Caring for Country - Five Mile Creek Reserve

We wish to draw your attention to the recent 'maintenance' works on the stormwater system at the top of the reserve which suggest that due consideration has not been given to the importance of this special place..

View from the bottom

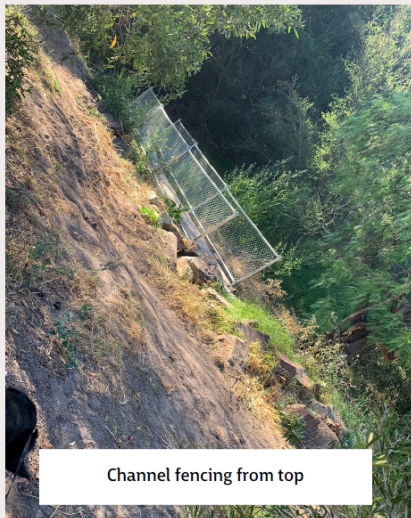
Washing out now diverted to lower ground
across footpath

Vegetation hacked and left at bottom

Channel fencing from top

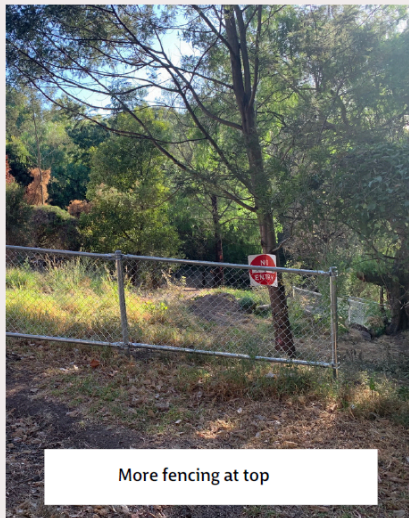
More fencing at top

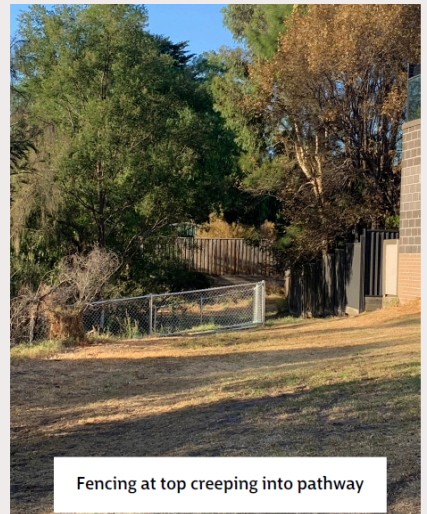
Vegetation remove and left at top

Materials left on site

Dead vegetation

Fencing at top creeping into pathway
